CR-5000/8000 SERVICE NOTES**SPECIFICATIONS***First Edition*

Second Printing (July 12, 1983 E2)

**CR-8000
CPU BOARD
GL3125-060
(731250600)
(pcb 2291046401)**

CR-8000
VOICING BOARD
VG3125-120
(7312512007)
(pcb 2291046302)

**CR-5000
CONTROL BOARD
GL3124-090
(7312409010)
(pcb 2291046501)**

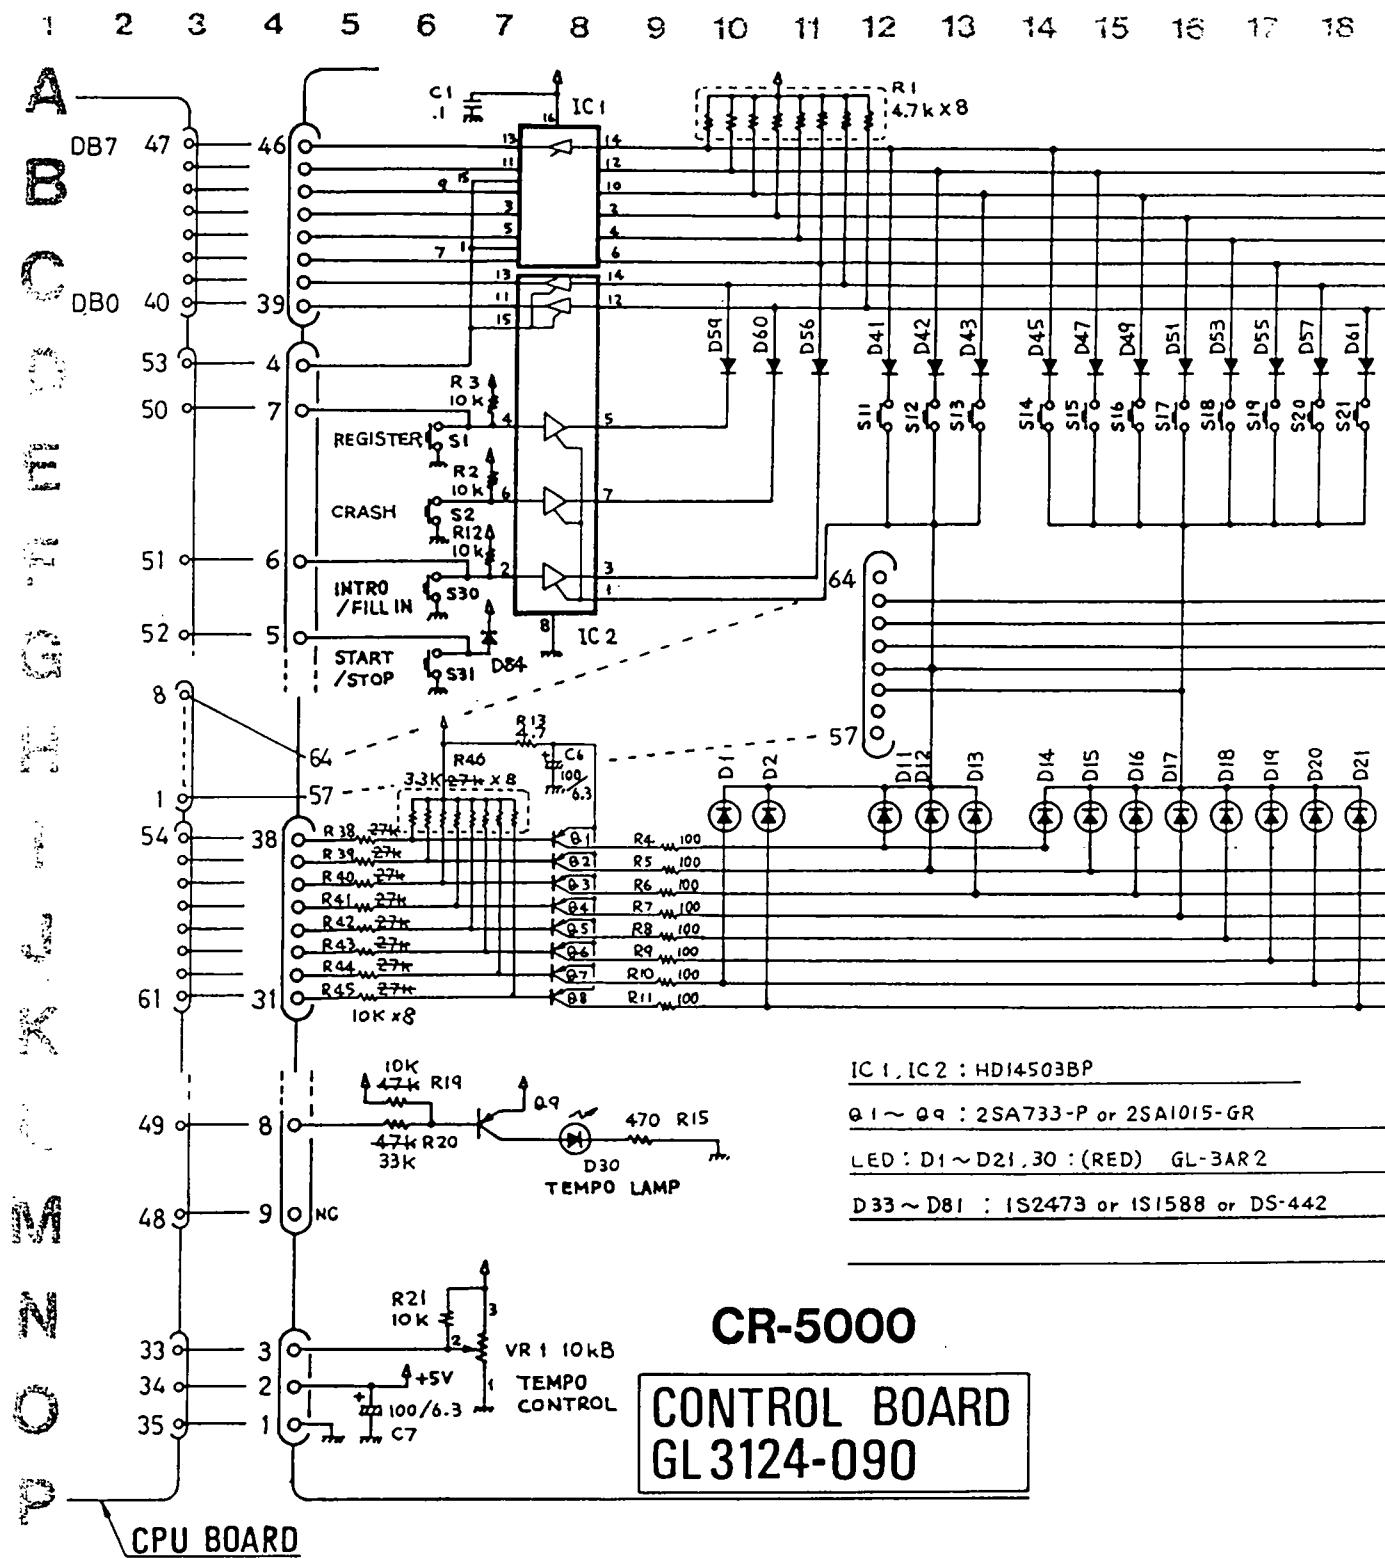
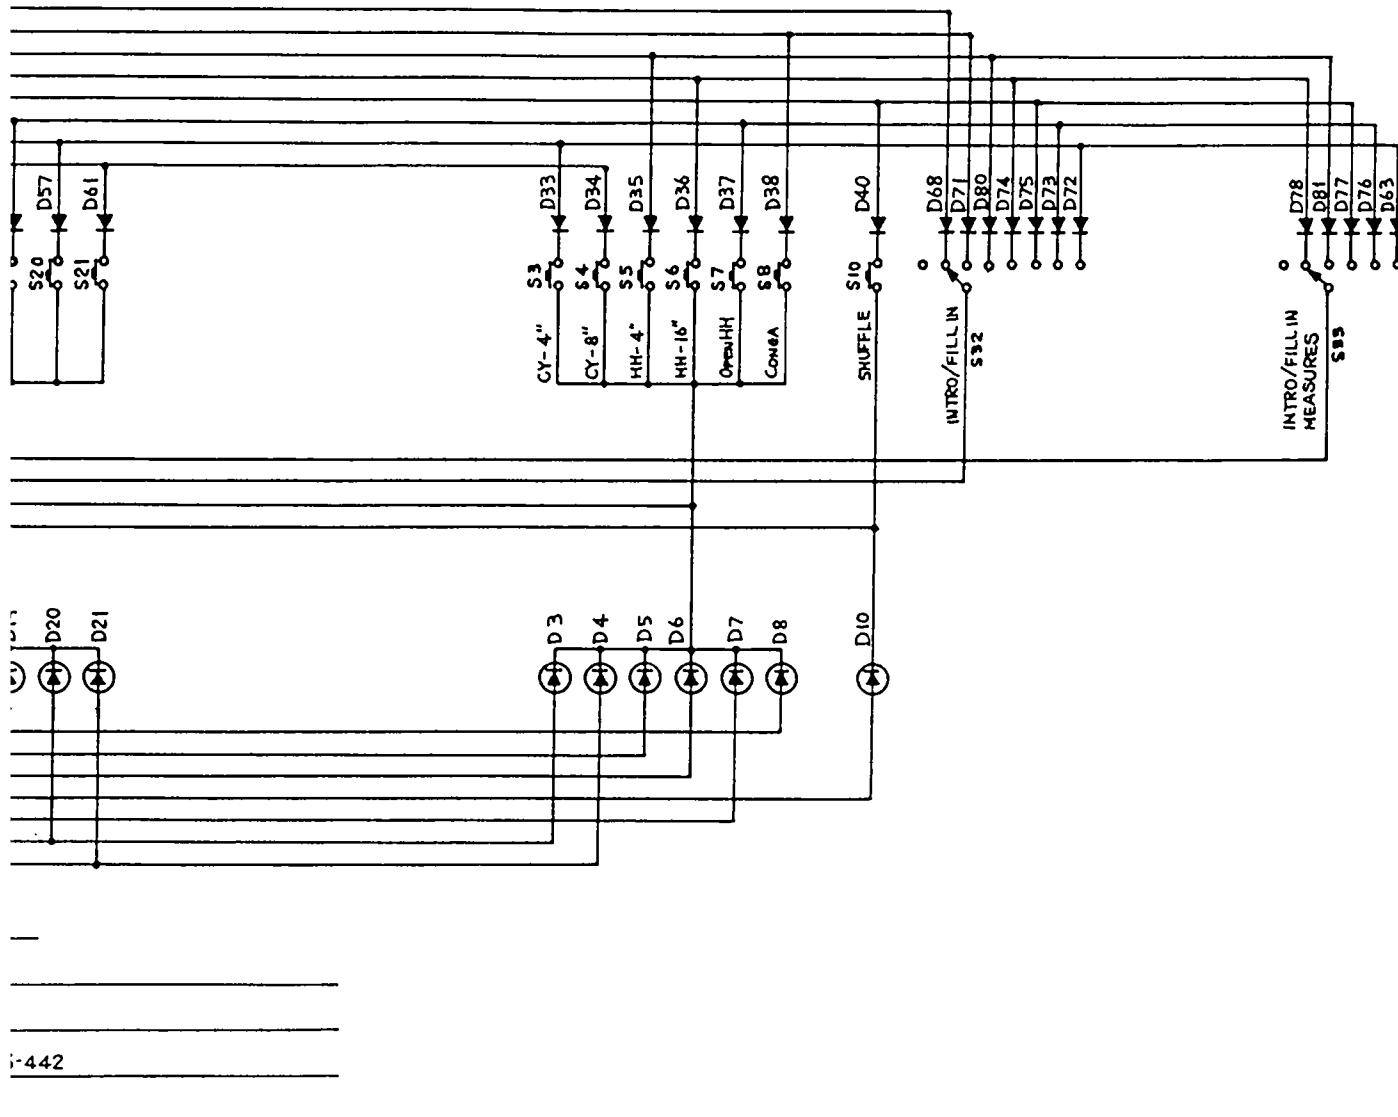
CHANGES IN RESISTANCE With Serial Number 091100 and up

R The changes eliminates possible dim lighting of LEDs due to insufficient current at IC1 or IC2 on CPU board:

S R38-R45: 27k to 10k R19: 47k to 10k R20: 47k to 33k
Resistor Array R46: 27k to 3.3k

**CR-5000
VOICING BOARD**

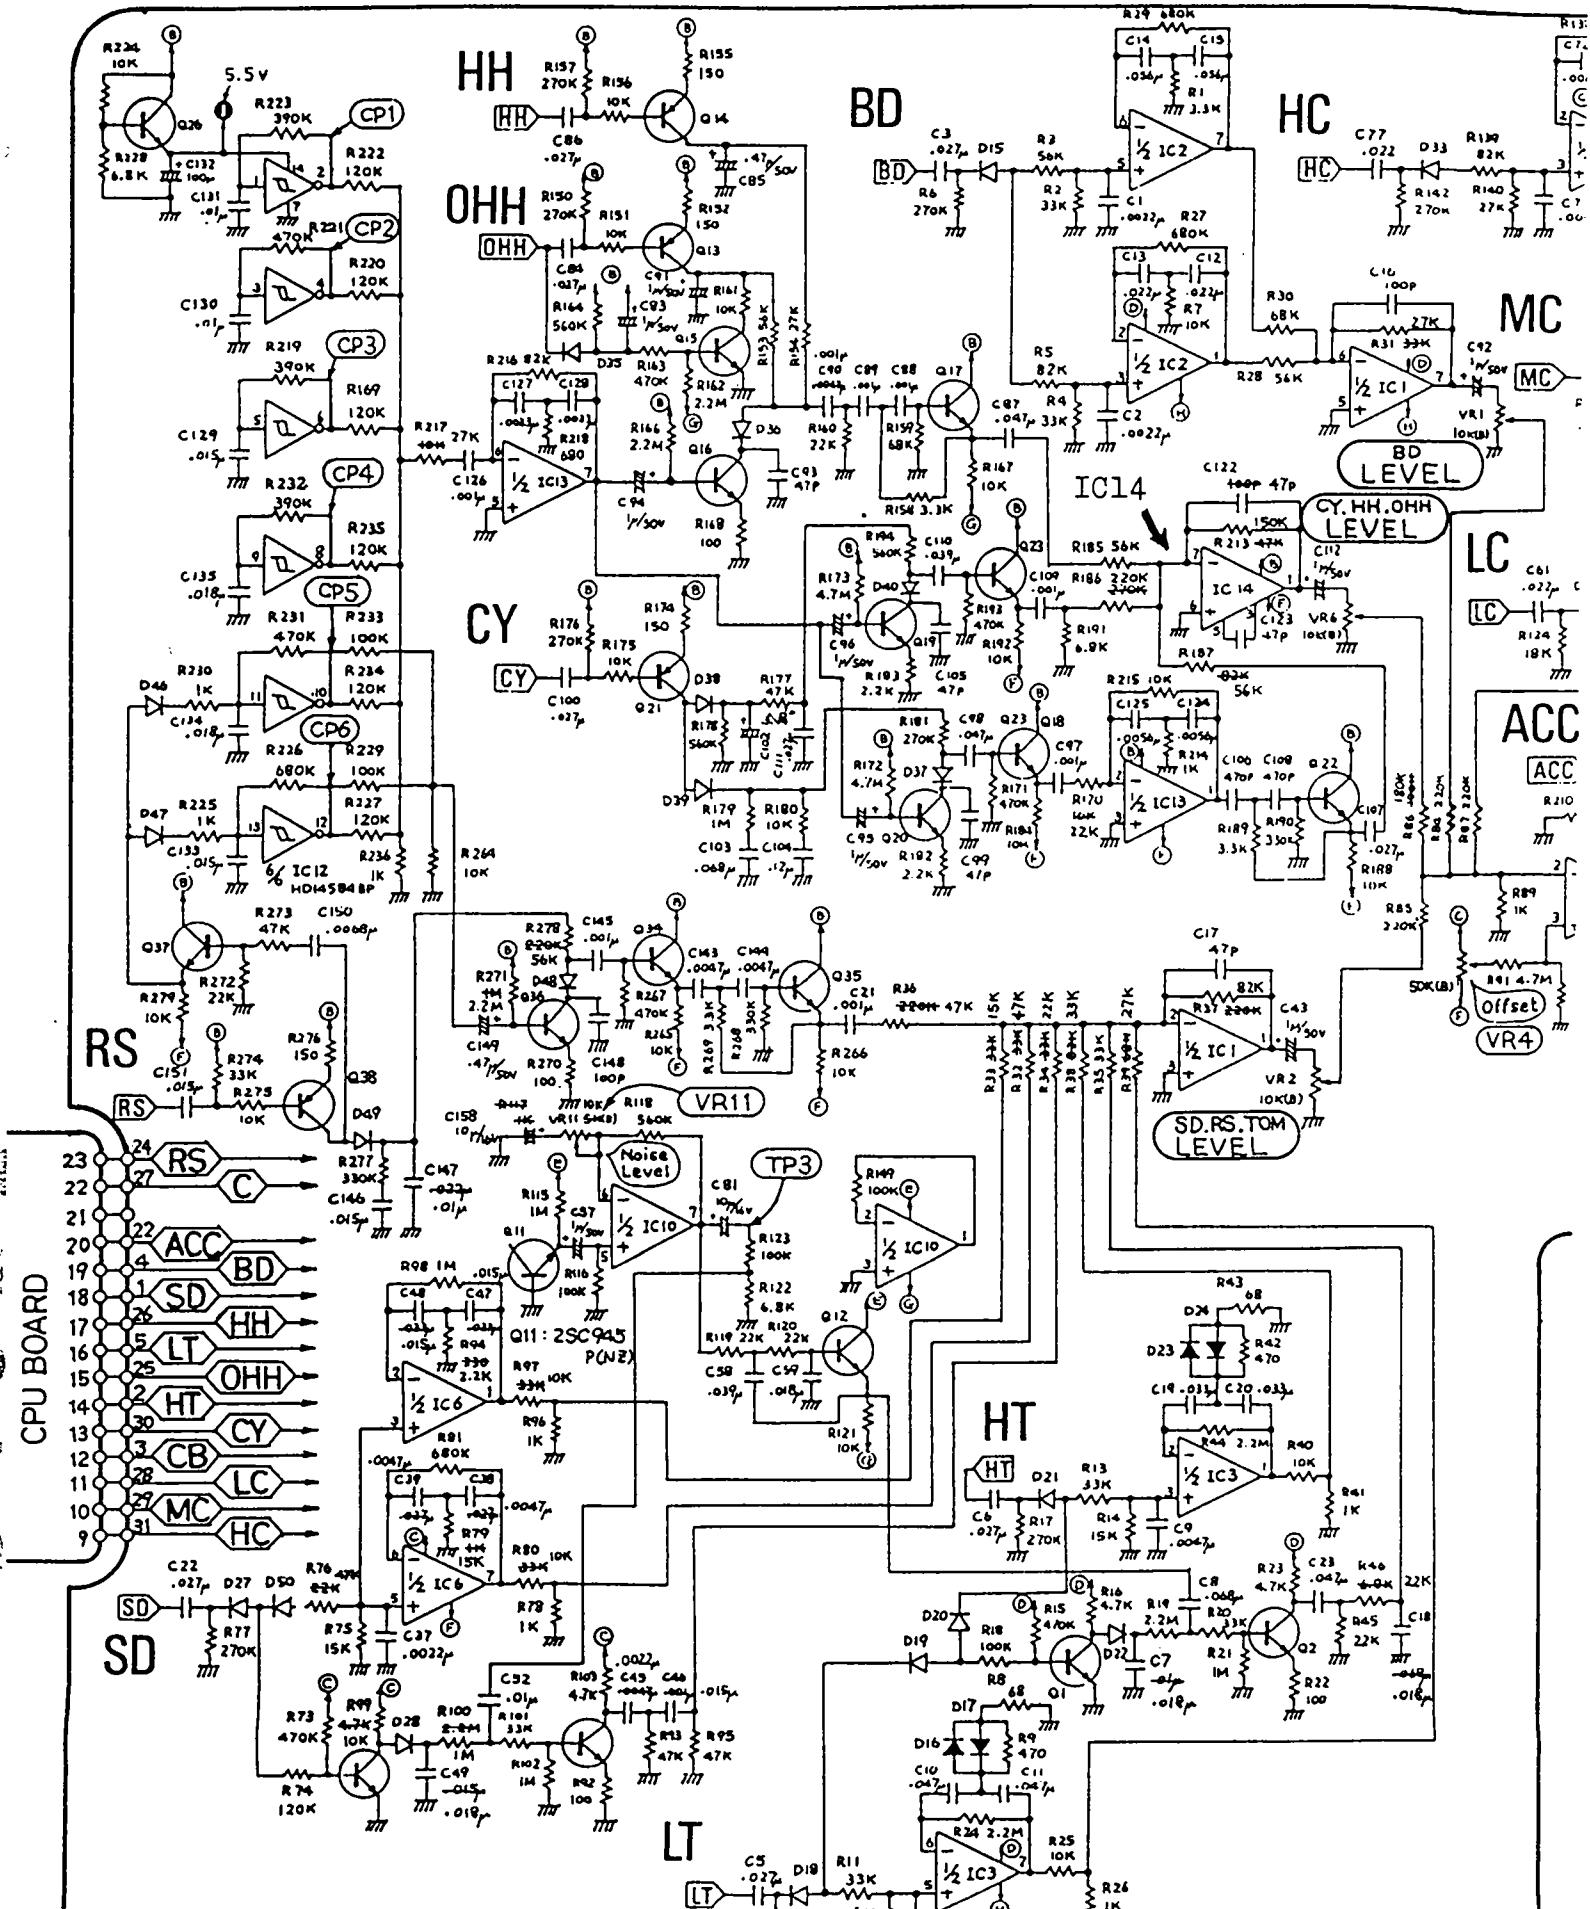
VR9
with S/N 091100
From 10k to 50k

NOISE GENERATOR

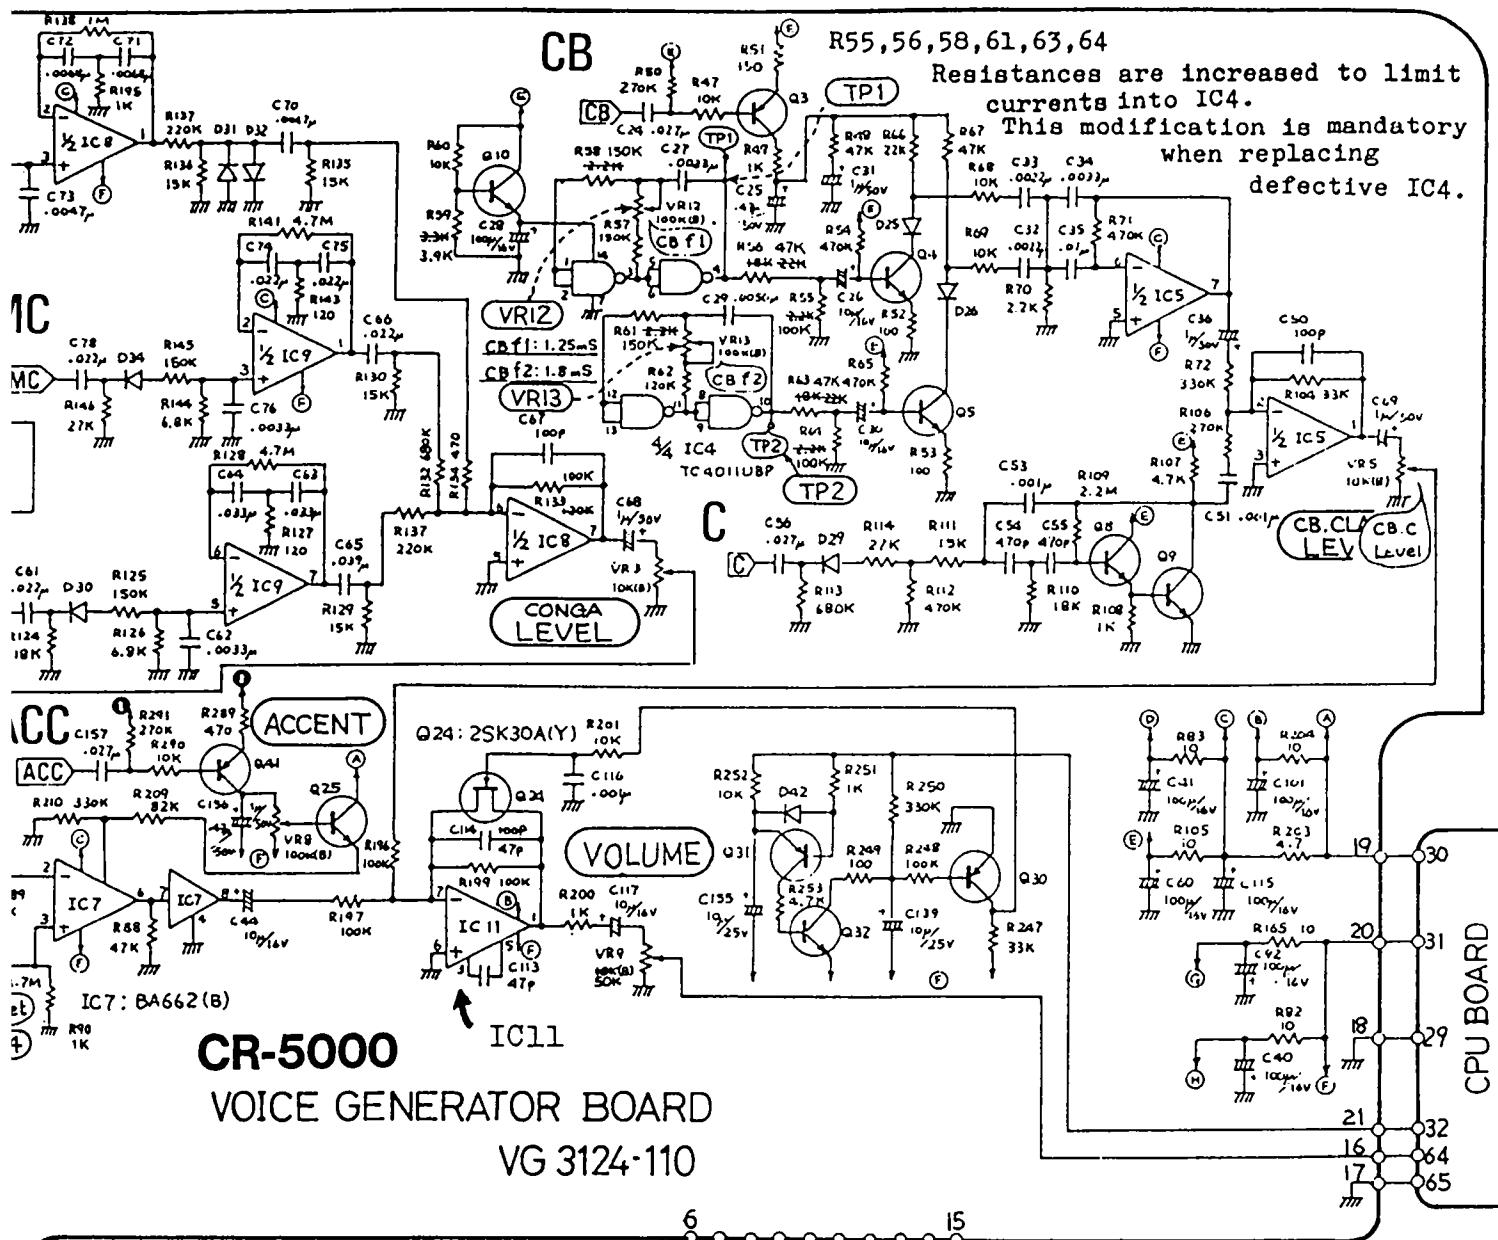
When $\frac{1}{2}IC10$ bias current is high, it heavily DC biases output waveform, narrowing headroom. (Flattened one peak at relatively small input signal.)

Decoupling capacitor makes DC gain of the IC unity.

CHANGING OPERATIONAL AMPLIFIERS

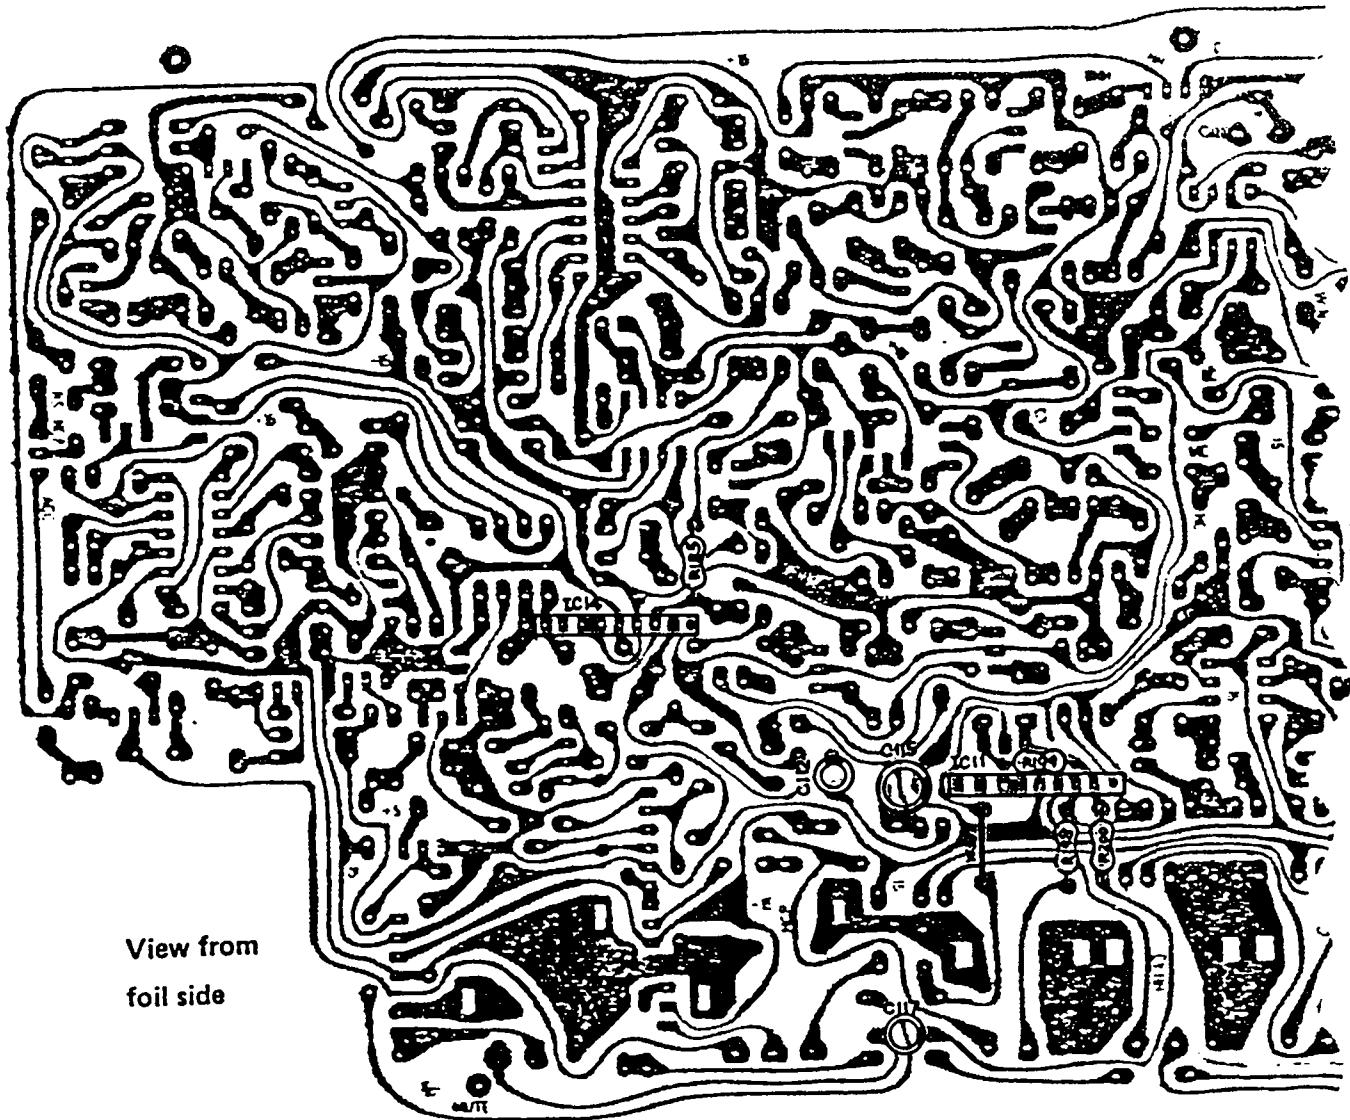
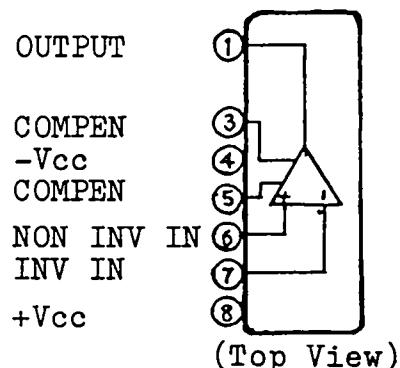
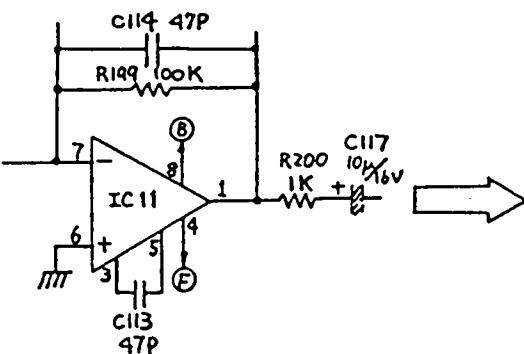
On CR-5000/8000 VG Boards as well as in other Roland products, the IC NJM4558S replaces HA1457W which is discontinued at the semiconductor manufacturer.

Incompatible pin arrangement leads to minor PCB re-layout as shown below, which is due to put into practical production.

Serial Numbers with which the change is effective on the CR-5000/8000 are not fixed as of the date this edition is closed.

NOTE: Although two OP AMPS are contained in new IC, one is left redundant in this application.
